Zoning Board of Appeals
Wednesday, July 08, 2026
5:30 PM

- 2. ZBA 2026-011: Design Review for a 440 SF Deck Addition with ADA Accessible Ramp located at 11087 Main Street** (PIN: 04-33-251-002).

Zoning Board of Appeals Meeting of July 8, 2026**Application No. ZBA 2026-011**

Requested Action: Approval of Design Review for Exterior Alterations

Site Plan

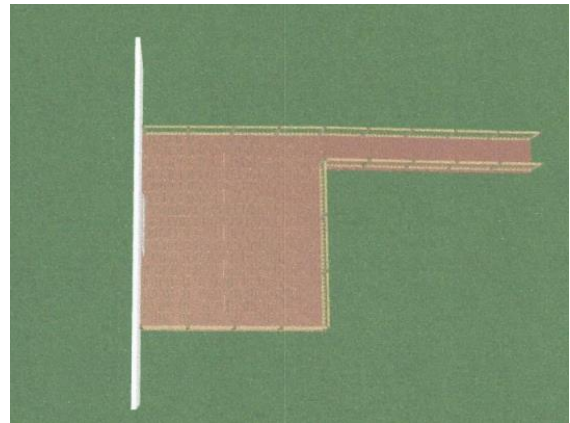
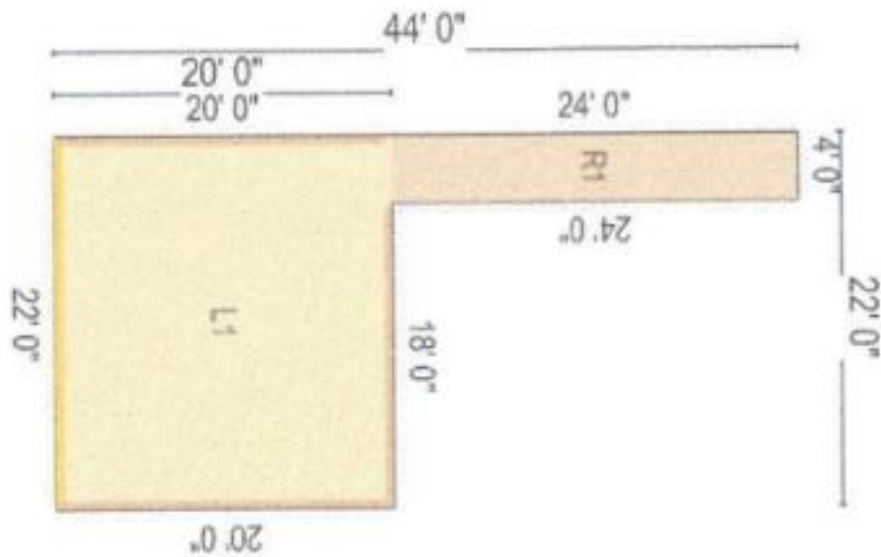
Building Design: The subject property is 1.02 acres in size and is developed with an existing one-story principal building and an accessory structure. The proposed project includes the construction of a 22-foot by 20-foot deck and a 24-foot by 4-foot wood access ramp at the rear of the building. The property contains an established use, and the proposed improvements are limited to modifications at the rear of the existing structure. The MS-C District does not require minimum side or rear setbacks; however, the proposed improvements exceed any applicable setback requirements. The Main Street District design standards are focused on new uses, new principal structures, and front-facing building facades. Based on the submitted plans, the proposed improvements are consistent with applicable code requirements and design standards.

Engineering Comments: Engineering has no concerns with the proposed project but requests that the applicant incorporate pavement striping into the project.

Staff Recommendation: Staff recommends approval of the Design Review for exterior alterations to the existing building within the MS-C, Main Street Core zoning district at 11087 Main Street, subject to the following conditions:

1. The applicant shall install the materials that have been reviewed and approved by the Zoning Board of Appeals.
2. The applicant shall obtain all necessary building permits.
3. The applicant shall install pavement striping within the parking lot in accordance with all applicable City ordinances (Sec. 15-617. - Design standards, access aisle, and space requirements).
